**TOWN OF NISKAYUNA**  
***Planning Board and Zoning Commission***  
**Agenda**  
**January 23, 2023 7:00 PM**

AGENDA ITEM NO. VIII. 1

MEETING DATE: 1/23/2023

**ITEM TITLE:** DISCUSSION: 1851 Union St / 1245 Ruffner Road – Mohawk Golf Club – application for sketch plan approval including a Special Use Permit for a 22-lot Average Density Development (ADD) subdivision consisting of 10 single-family detached homes and 12 townhomes.

DATE: DECEMBER 6, 2022 SCALE: 1" = 50' DWG. 5429A-S4 AVG SHEET 1 OF 2

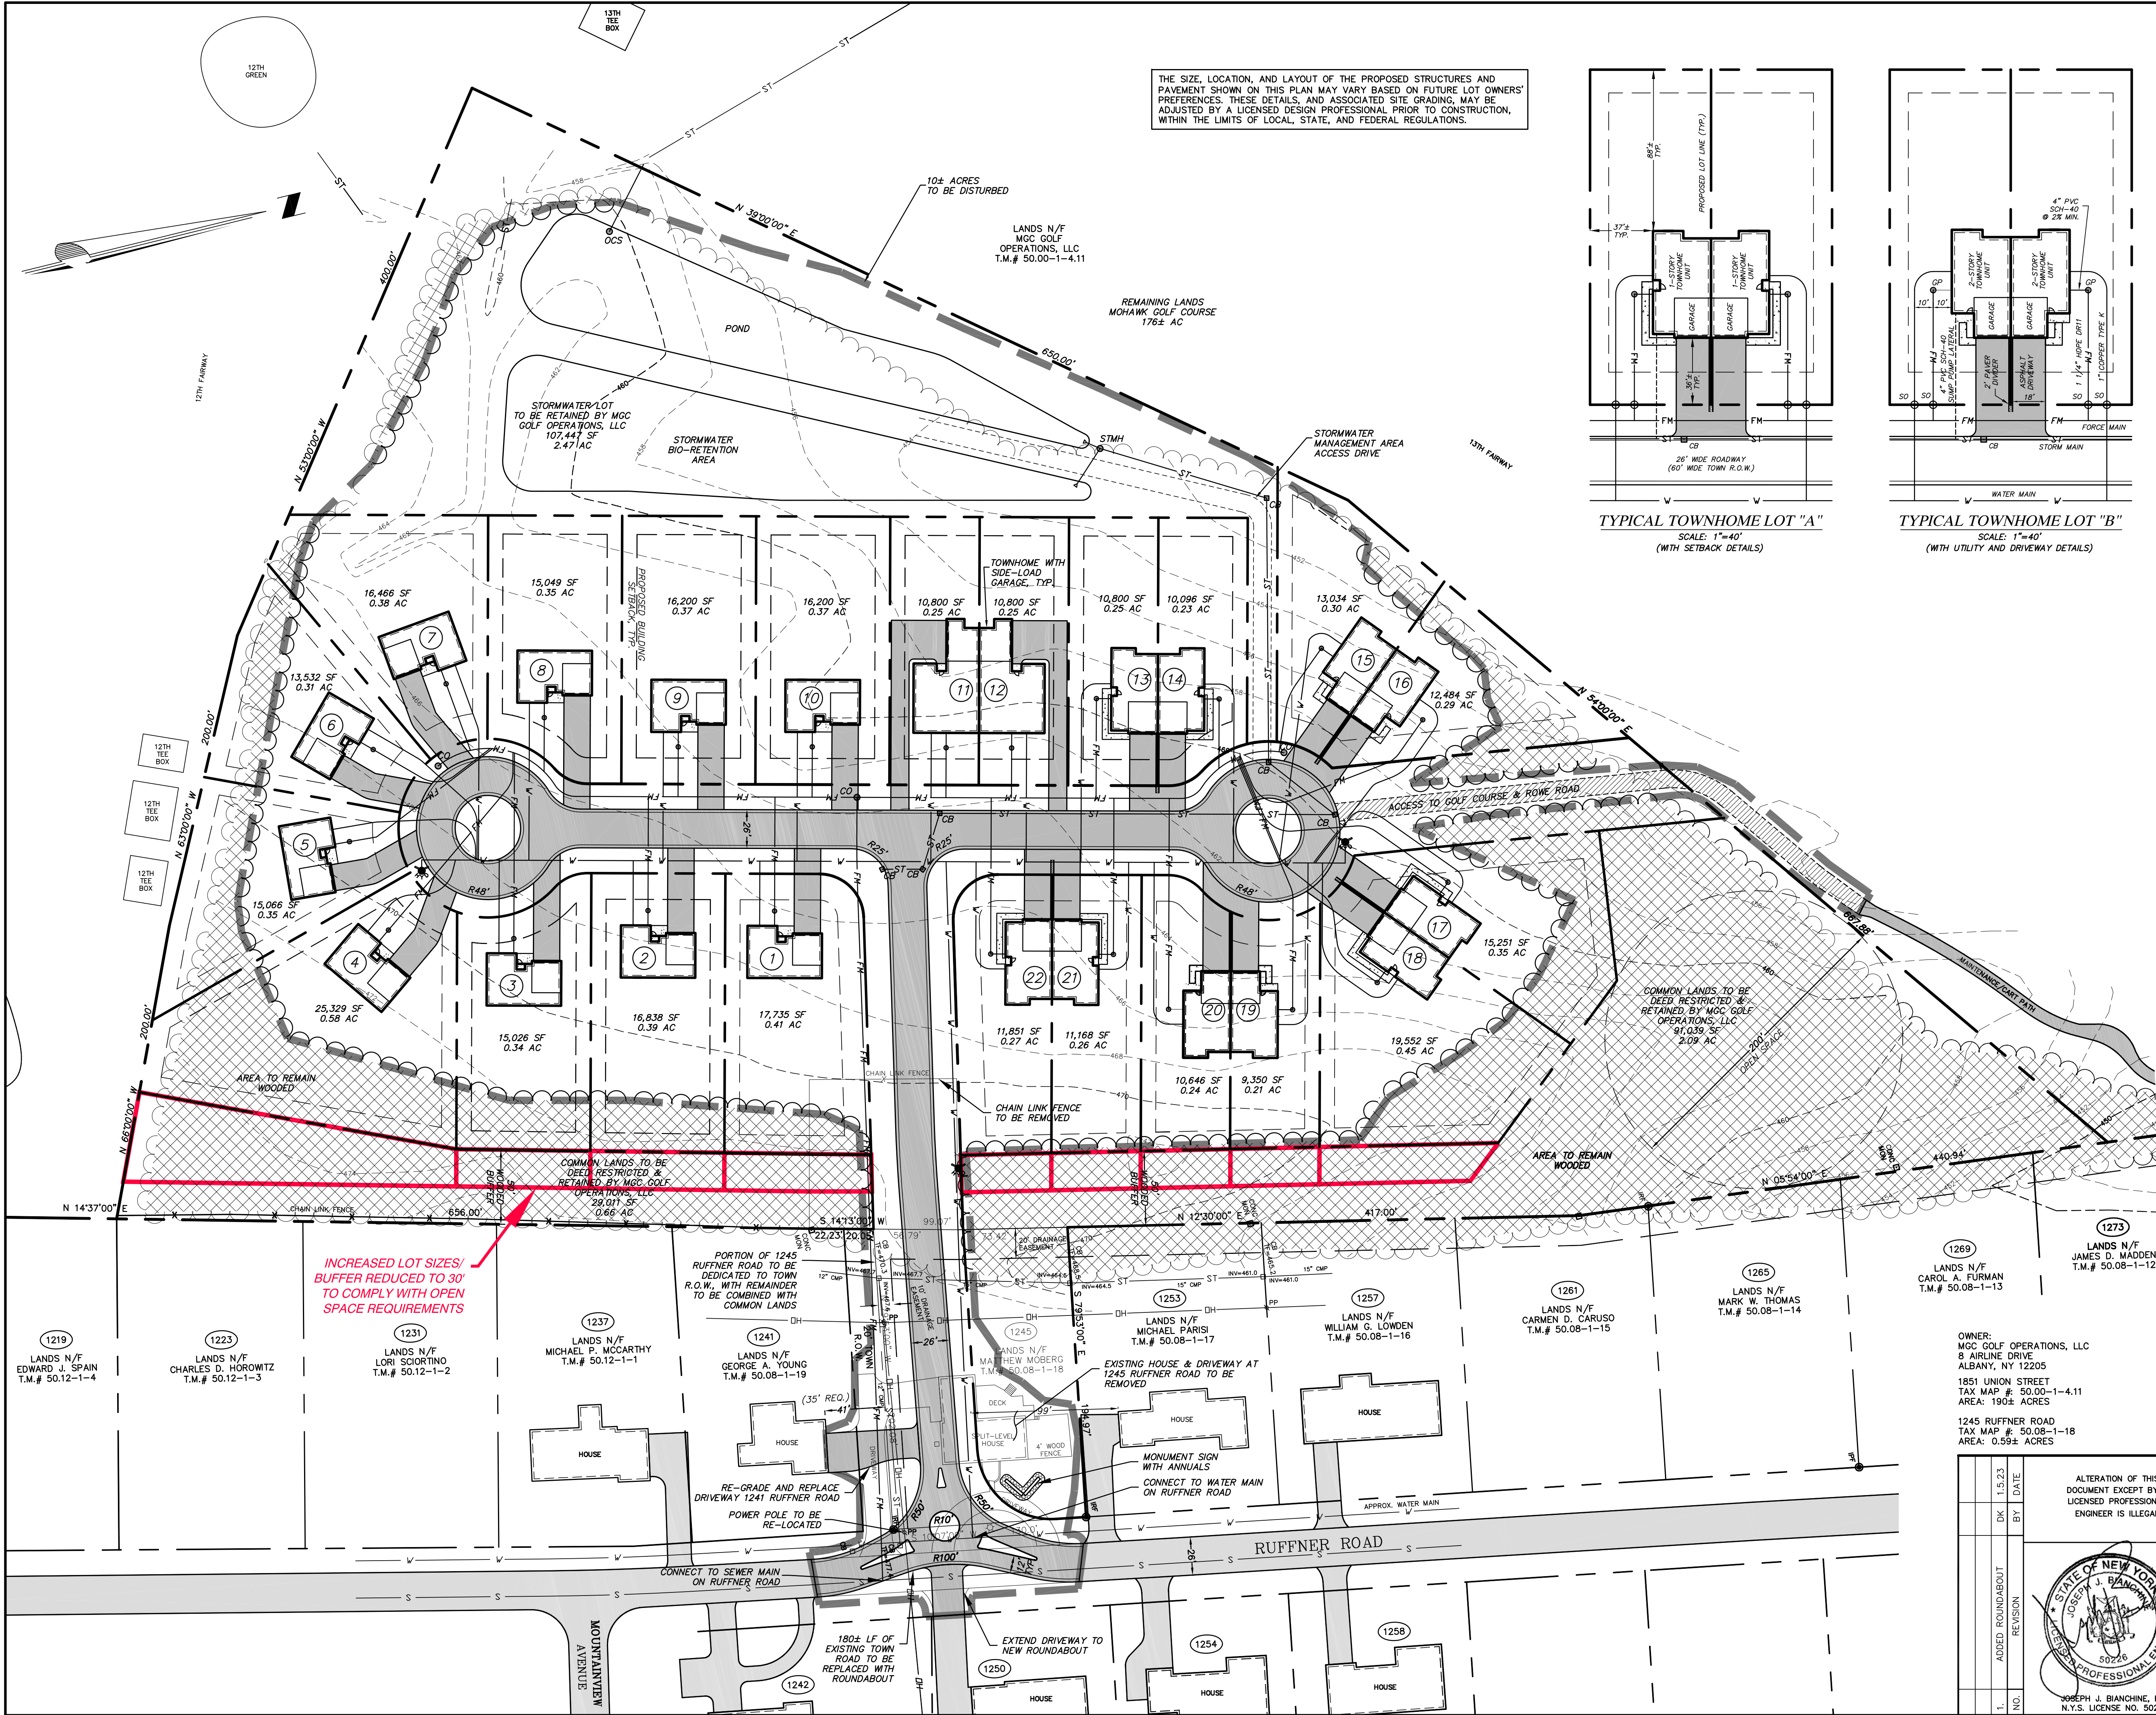
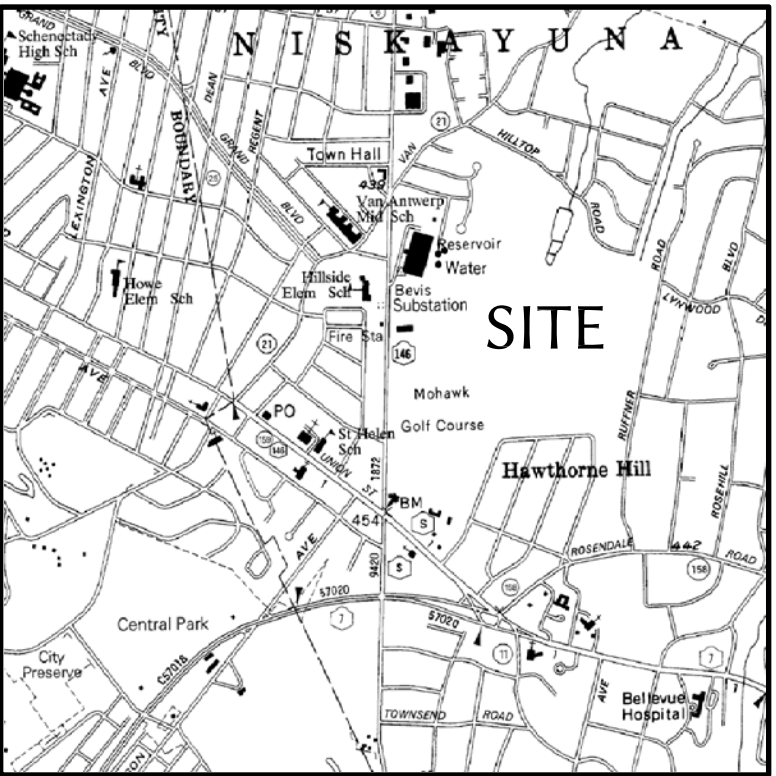
12/6/22 -- The applicant provided the Planning Office with a significantly revised site plan design and documentation set on 12/6/22. The following documents were stamped "Received Dec 06 2022 Planning Office Niskayuna, NY".

The project summary letter describes the revised design as an Average Density Development subdivision consisting of a mix of 12 townhomes and 10 single family homes. The letter also includes the following description of the changes.

1. A secondary access to the subdivision is now shown in the plans. A 12' wide grass paver access road will connect to the existing golf course maintenance / cart path via a full width 60' Town R.O.W. stub off of the northern cul-de-sac.
2. There are two "Sheet 1s" included in the plan set. The second Sheet 1 demonstrates that it is possible, although less desirable, to meet the open space requirements for an ADD project set forth in Niskayuna zoning code Section 220-28 F (4) (a).
3. A separate color exhibit is included which demonstrates why building roads from either of the existing access points to the north or south along Ruffner Road would not be possible without steep slopes or excessive disturbance to existing golf course features and / or neighboring properties.

12/7/22 Conservation Advisory Commission (CAC) – The CAC reviewed the 12/6/22 site plan drawings. Mr. Kimmer of ABD Engineers and Mr. Sweet of the Mohawk Club attended the meeting and explained why the design has shifted back to an Average Density Design (ADD). They noted that a secondary emergency access road off of the north end of the property is included in the revised design. They explained that the project now includes 10 single-family homes and 12 townhomes and complies with all of the requirements of an ADD subdivision.

12/12/23 Planning Board (PB) meeting – Dave Kimmer, of ABD Engineers, and Bill Sweet of the Mohawk Club attended the meeting and described the revised site plan. Mr. Kimmer explained that the applicant had reimagined the project and is no longer pursuing 22 townhomes. The project is now proposed as an Average Density Development (ADD). This eliminates the need for the 67 area variances. He noted that ten (10) single-family detached homes are included and that an emergency access path was added. After a general discussion the Board stated they would prefer to provide access to the proposed development via. an existing easement or the extension of an existing road rather than demolishing an existing home to create room for a new road. They asked the applicants to explore providing access from East Country Club Drive. Dave Kimmer agreed to explore this option. The Board also reviewed and discussed the open space requirement of an ADD project.

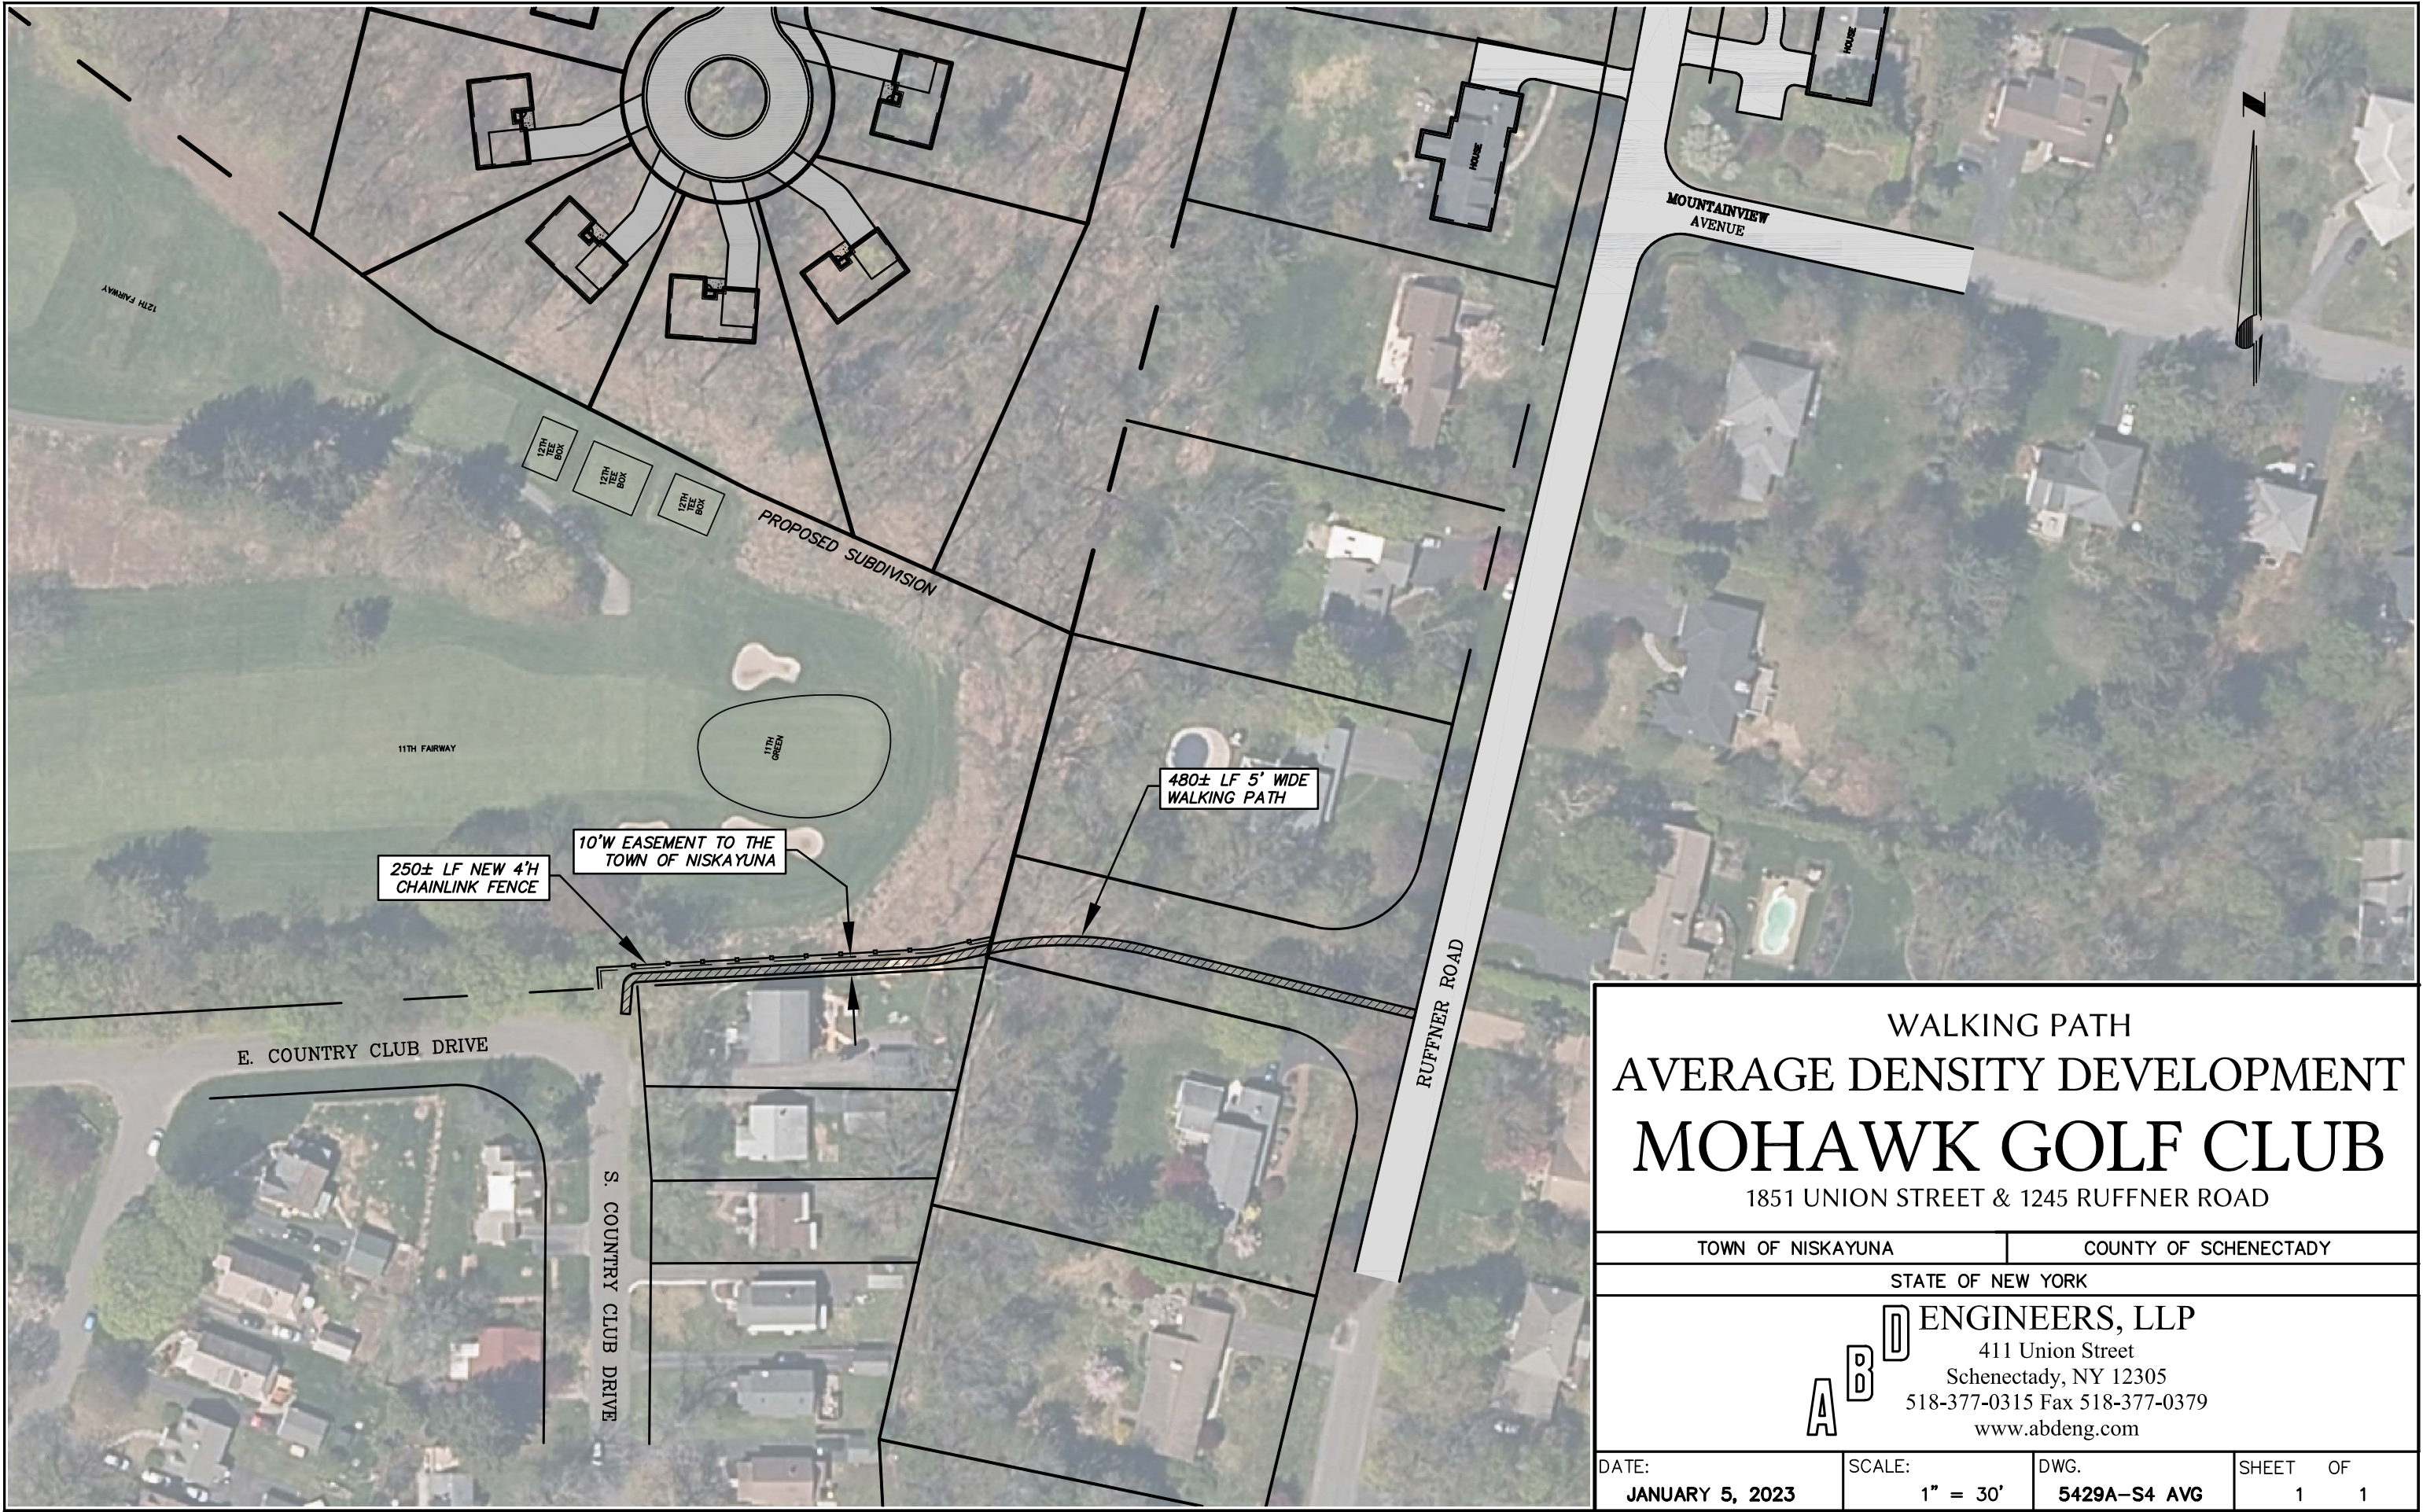
1/23/2023 UPDATE: Dave Kimmer provided the Planning Office with the following documents in response to the action items noted in the 12/12/23 PB meeting.

- A modified site plan that now includes a roundabout at the intersection with Ruffner Rd to calm the existing traffic on Ruffer Rd and help mitigate impacts caused by the ADD project.
- An exhibit showing a proposed walking path connection between East Country Club Drive and Ruffner Rd.
- A typical townhome image with a side-load garage
  - Floor plans and elevation view images are included
- A 3-sheet traffic exhibit and document with supporting calculations (using ITE Trip Generation, 9<sup>th</sup> Edition)
  - The documents compare the estimated traffic (trip) impact of the ADD “as proposed” to the traffic impact that could be expected if alternative access points to the south and north are used thereby creating a “thru connection”.
